RE: Alteration of Terrain Permit Application #250327-055
Jennesstown Manor
Tax Map 7, Lots 39 & 39-1 – Warner

Our office is in receipt of the Alteration of Terrain third request for information comments dated December 16, 2025. Based on the comments, we have made the required modifications and attached revised plans for review. A response to each comment has been provided below.

Alteration of Terrain Application & Stormwater Drainage Analysis

Jennesstown Manor

POST-DEVELOPMENT DRAINAREAS PLAN

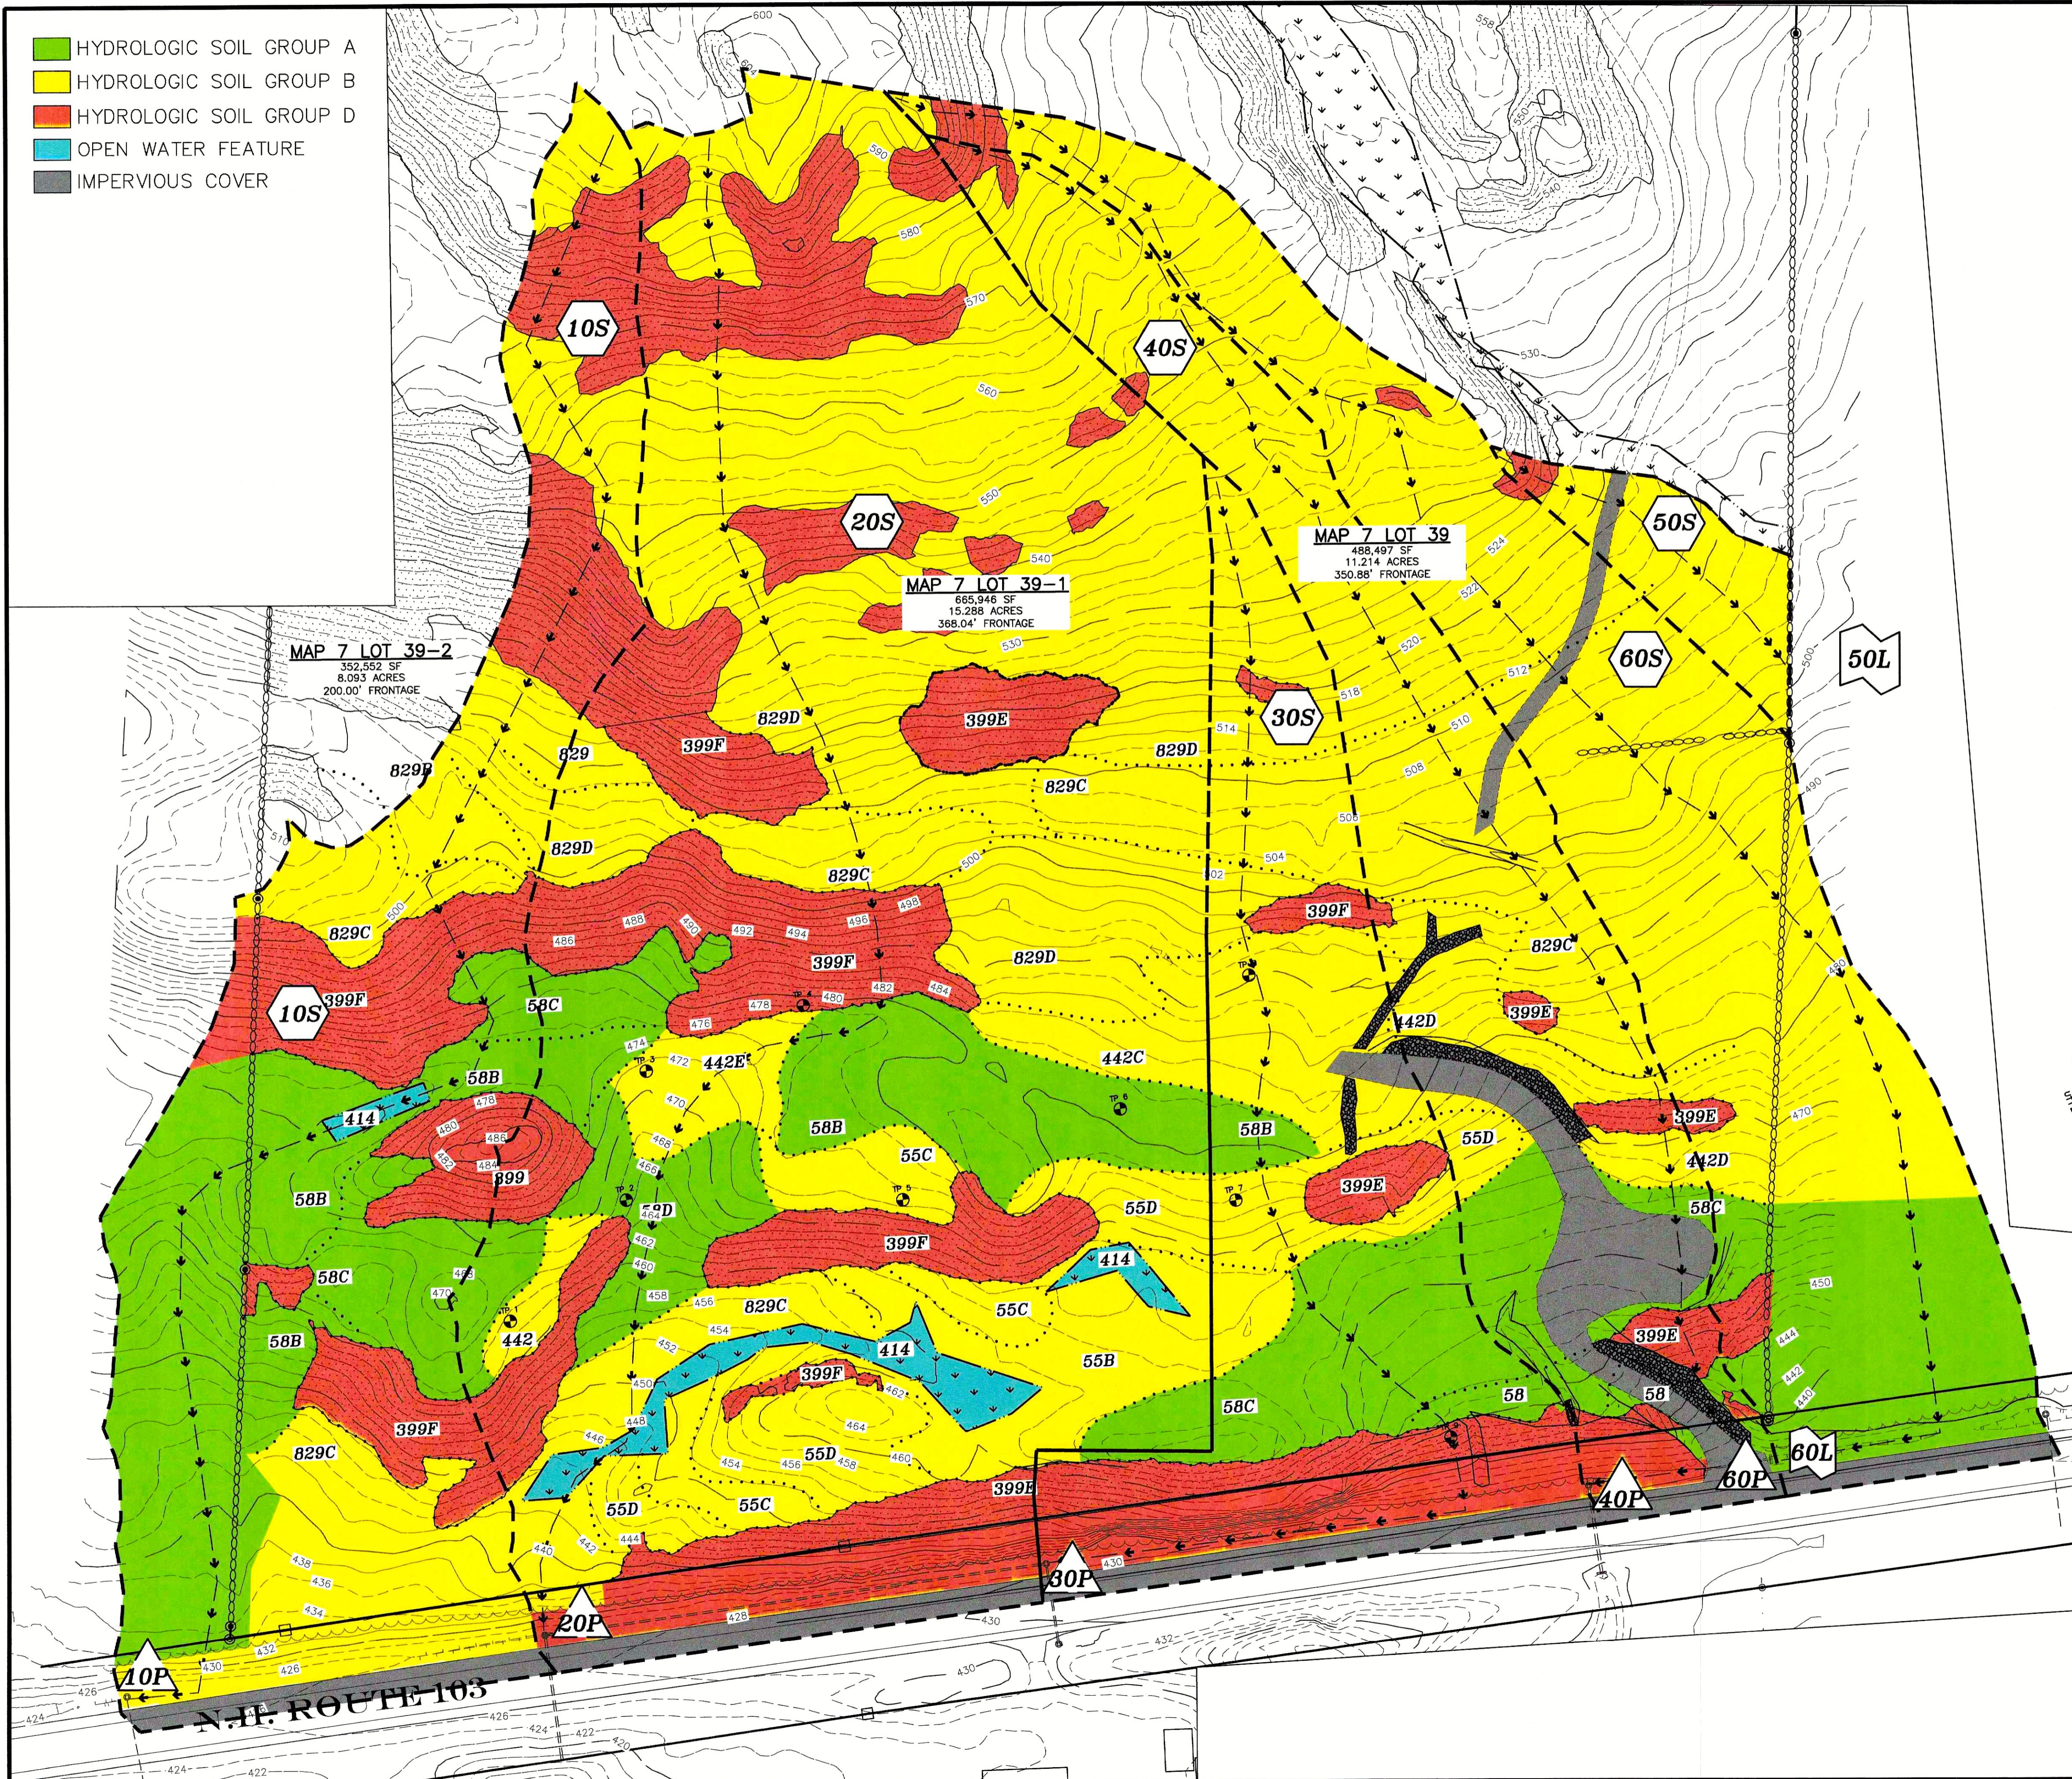
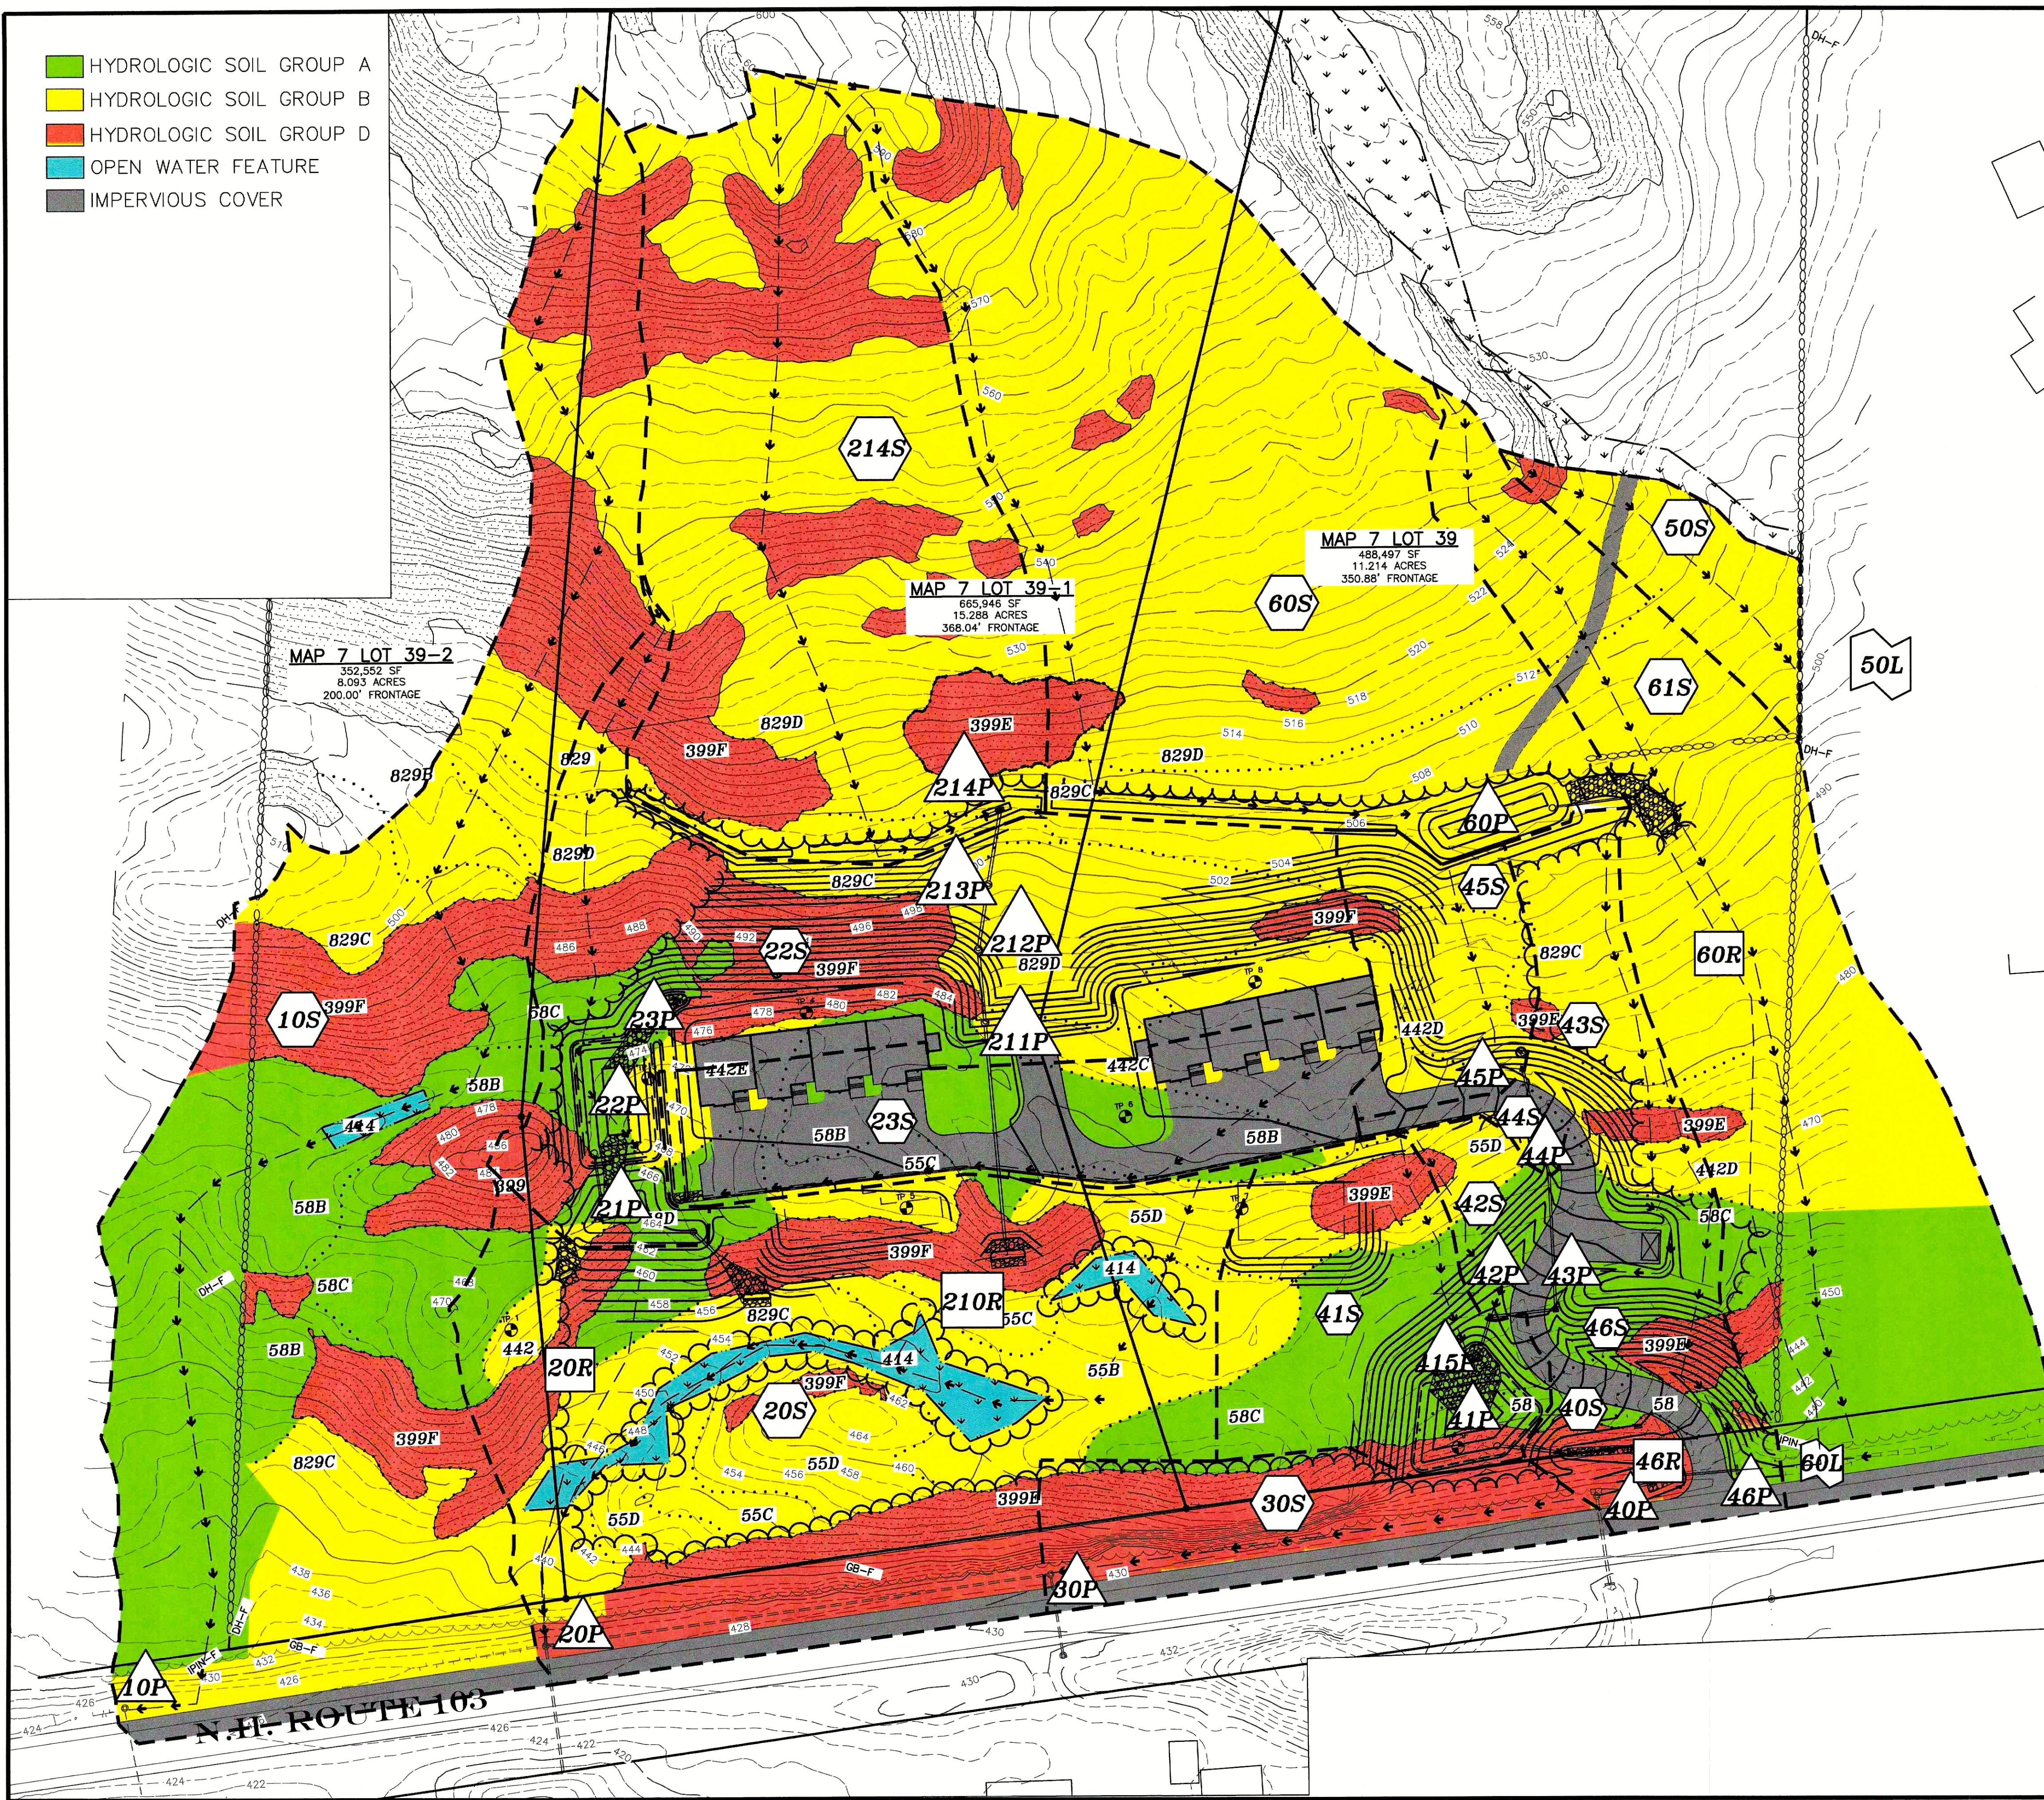
- Provide drainage area plans separate from bound report per Section 11 of application form.

- Plans need to be stamped, signed, and dated by a Professional Engineer (PE) registered in the State of New Hampshire in accordance with Env-Wq 1504.01(e).

Drainage area plans are separate from the bound report as their own file. The pdf contains two copies of the plans: the first is stamped then scanned and the second is computer generated pdfs without stamps.

Drainage and hydrologic soil group plans are now stamped.
